April 13, 2022

**RE: Green Ridge Recycling and Disposal Facility, LLC
Supplement to Response TR-1 (October 1, 2021)
Notice of Intent and Part A Application - SWP 626
DAA Job Number: 18020117-090102**

Listed below are DEQ comments #11, #14, #15, and #16 (in italics), followed by our corresponding response.

UPDATED CROSS SECTIONS B, D, E, AND F

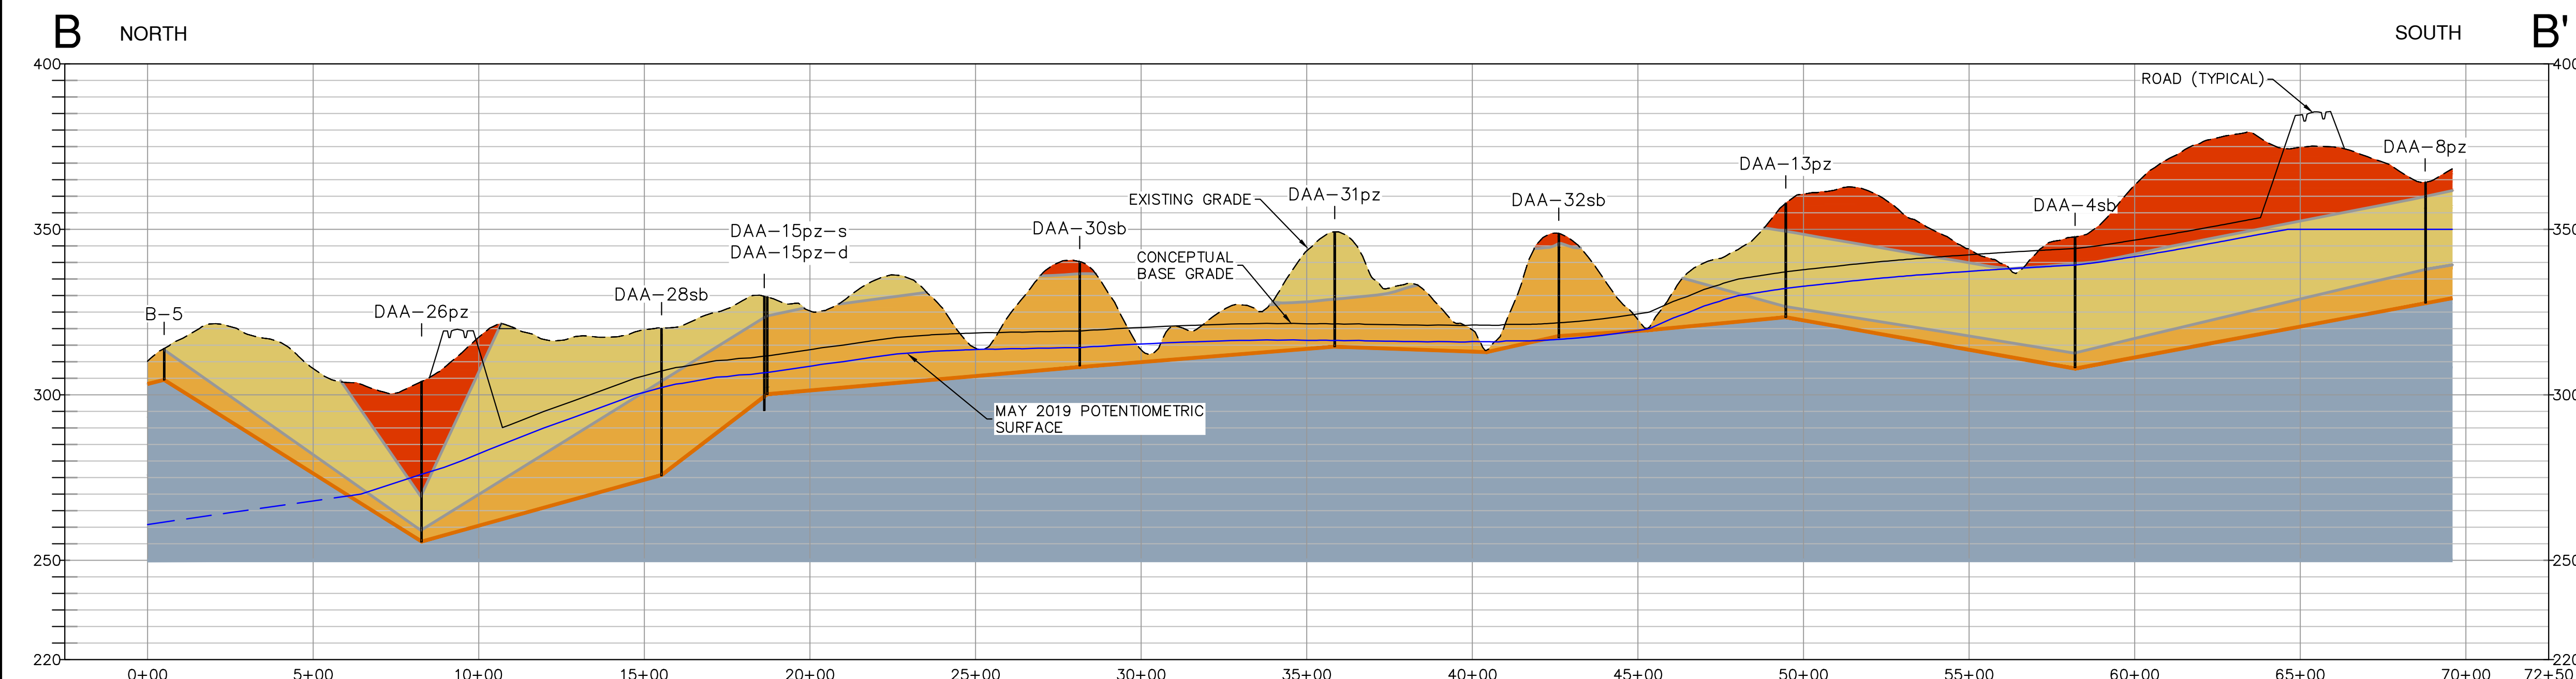
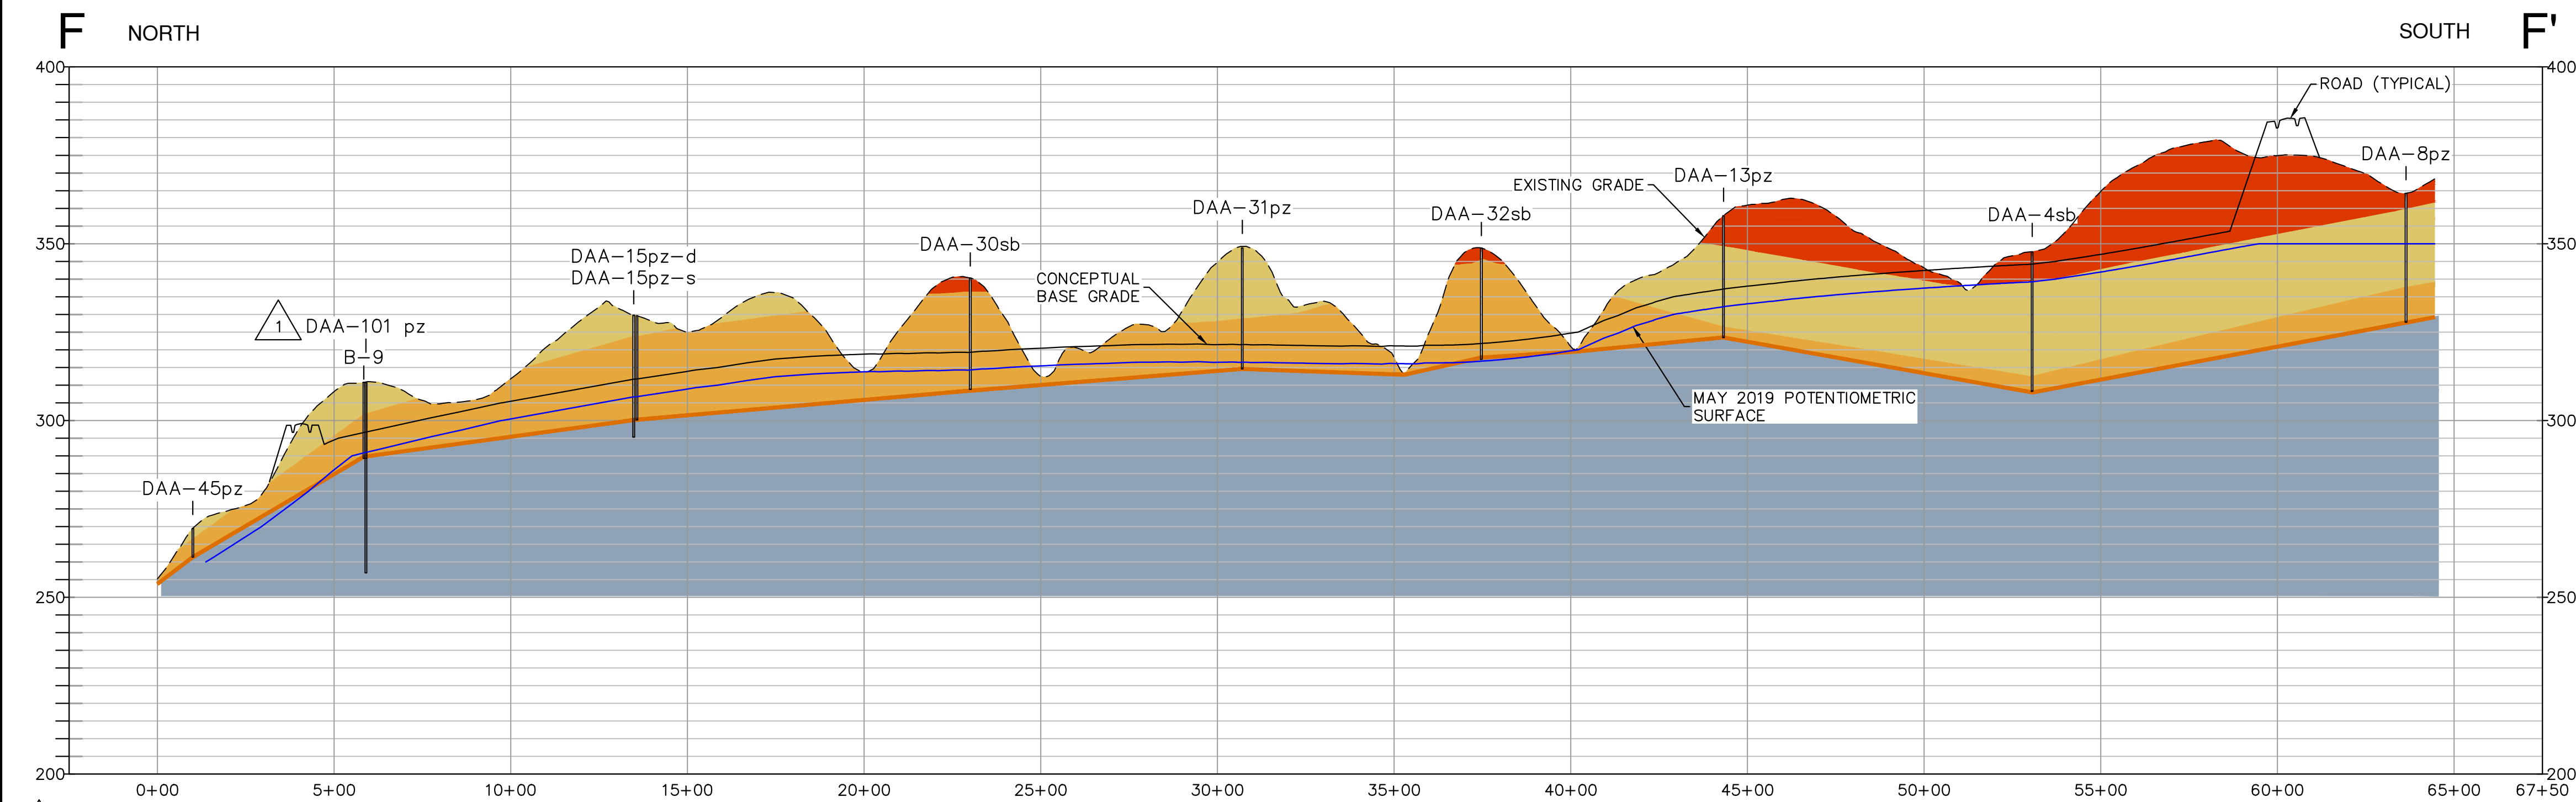
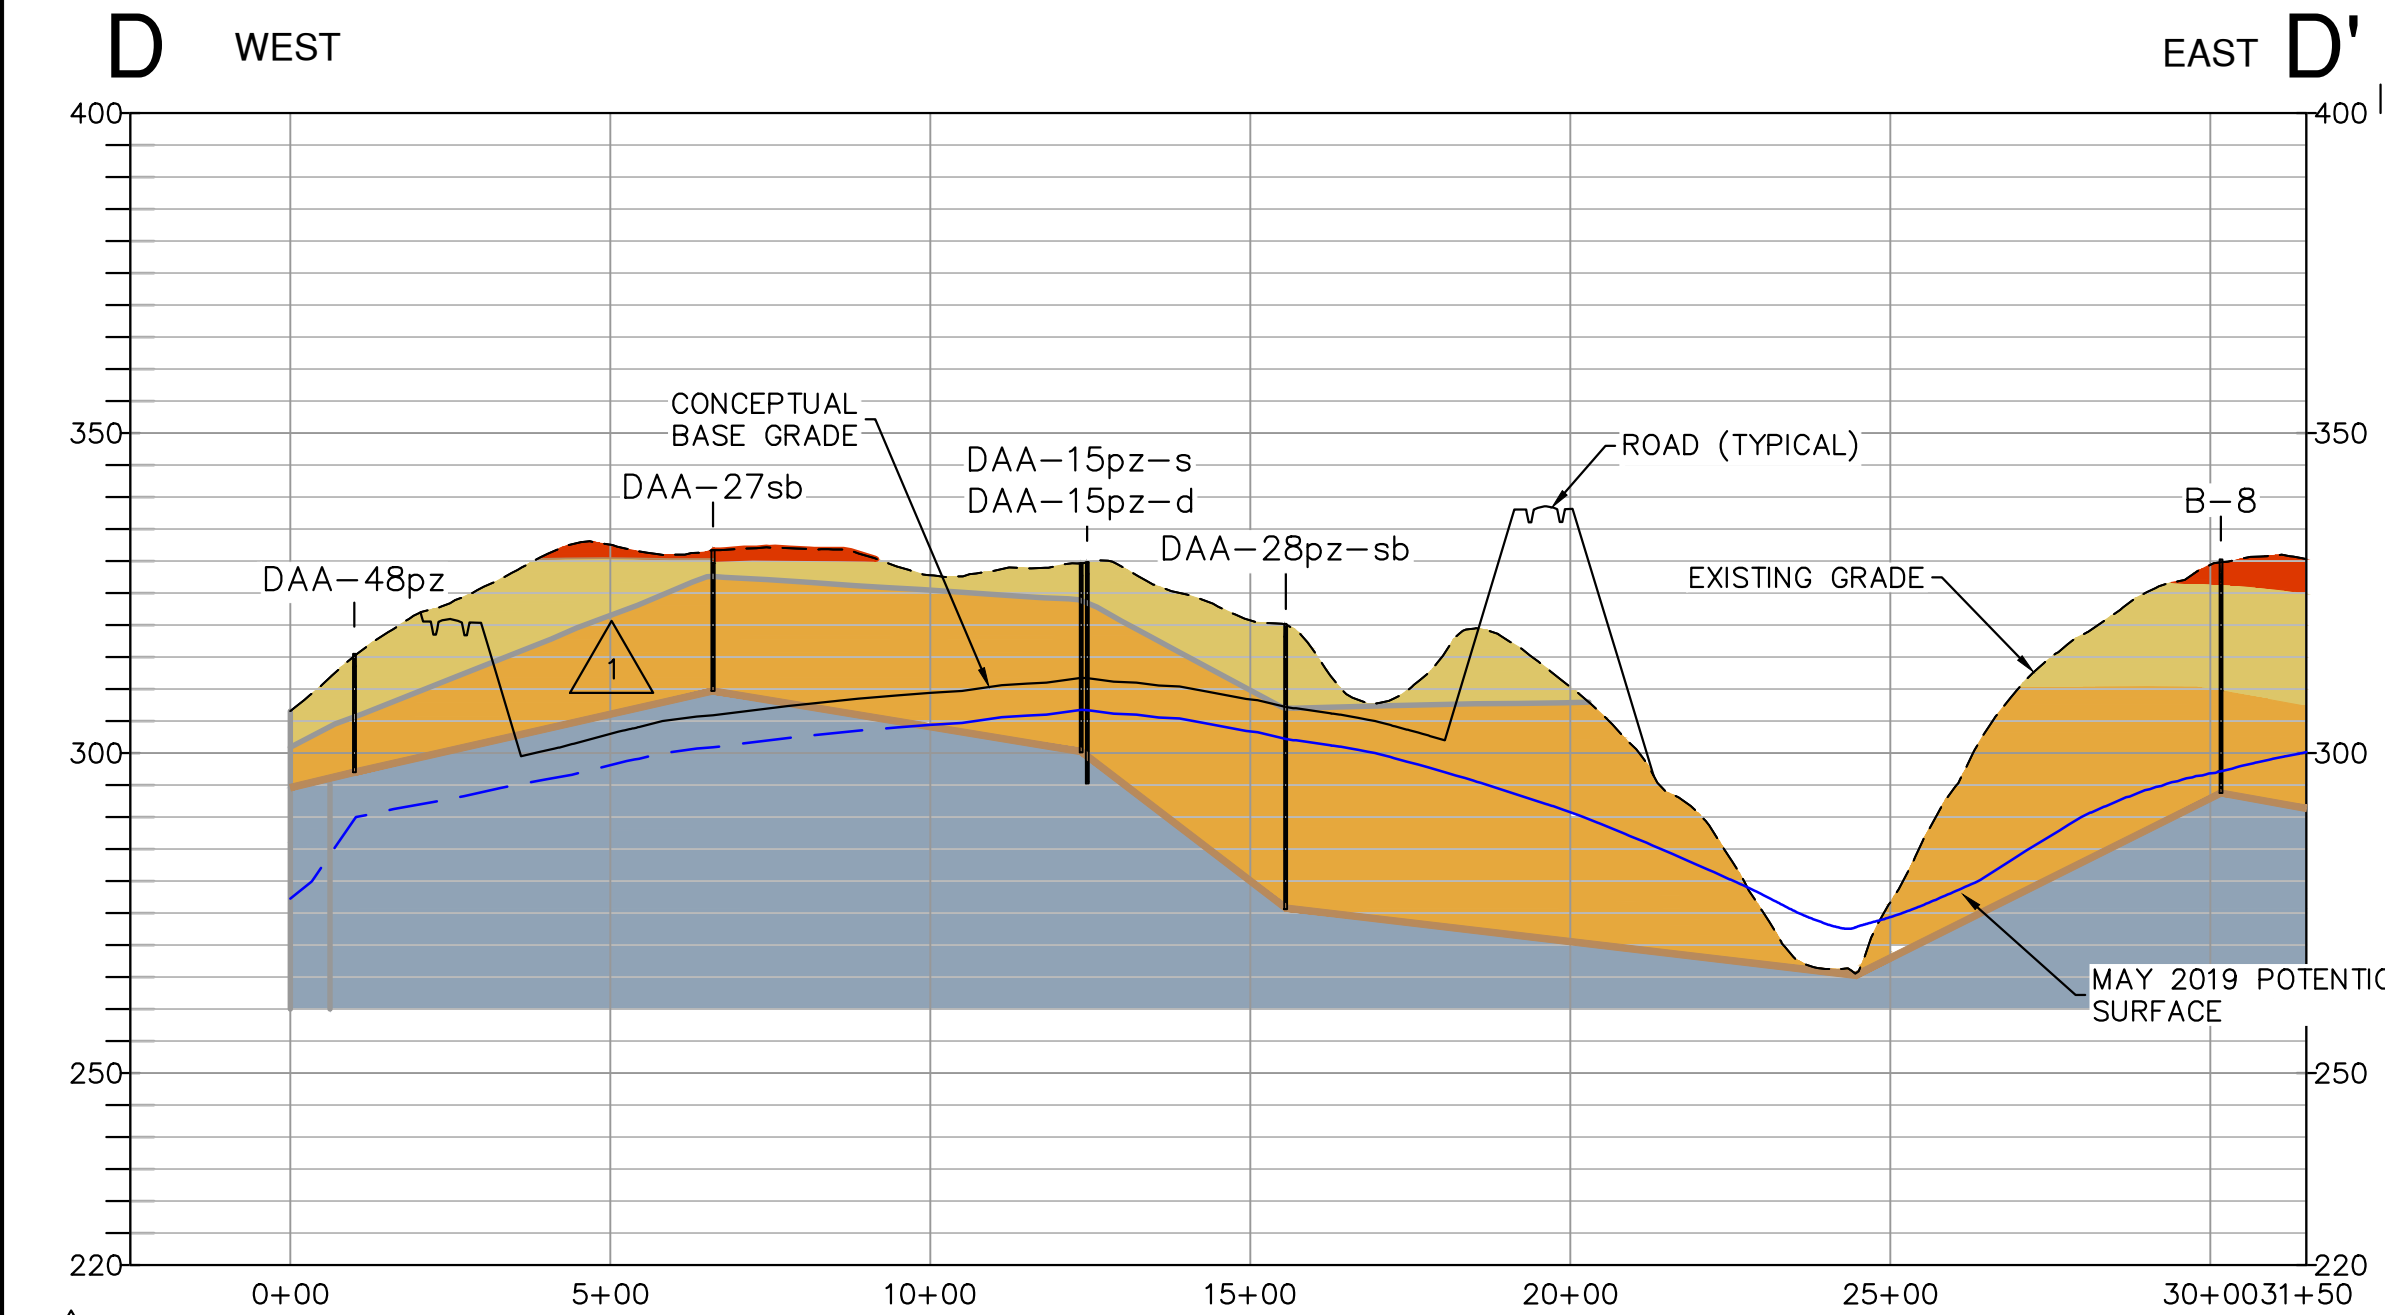
DEQ Comment #11: *The proposed base grades depicted in Attachment XV of the Part A Permit Application show the base grades constructed 10 to 25 feet into the bedrock in some areas (e.g., South of B-5, and near DAA-27sb). However, it appears that none of the borings performed for the Part A Permit Application were installed more than 10 feet into bedrock at the site. In accordance with 9 VAC 20-81-460.E.1.e., at least one deep boring should be installed into bedrock where the deepest base grades are proposed. The bedrock should be cored continuously for the first 20 feet below the proposed base grade. This will provide necessary information in accordance with 9 VAC 20-81-120.D.1 regarding the rate and direction of groundwater flow in the bedrock, ability to monitor groundwater in bedrock, the need for blasting or adjustment of base grades, potential hydraulic inter-connection with other regional groundwater wells, etc.*

Attachment 6 contains a drawing entitled PTA ATTACHMENT XV - FIGURE: CROSS-1 - Revision 1 - "Revised Cross Sections B, D, E, and F," dated 04/12/2022, prepared by Draper Aden Associates and includes updated cross-sections D-D' and F-F', which transect the northern section of the disposal cell. *This figure replaces FIG LA-11 submitted with our October 1, 2021 response.*

Cross-section F-F' has been updated to include the information from deep boring/piezometer DAA-101pz, including the most recent groundwater elevation. Additionally, cross-sections D-D' and F-F' have been updated to show the currently proposed base grades, which were raised to approximately 5 feet above the groundwater elevations in this area. DAA will continue to collect groundwater elevation data at the facility so that final design base grade elevations are a minimum of five feet above the seasonal high groundwater table, as determined by the measurements.
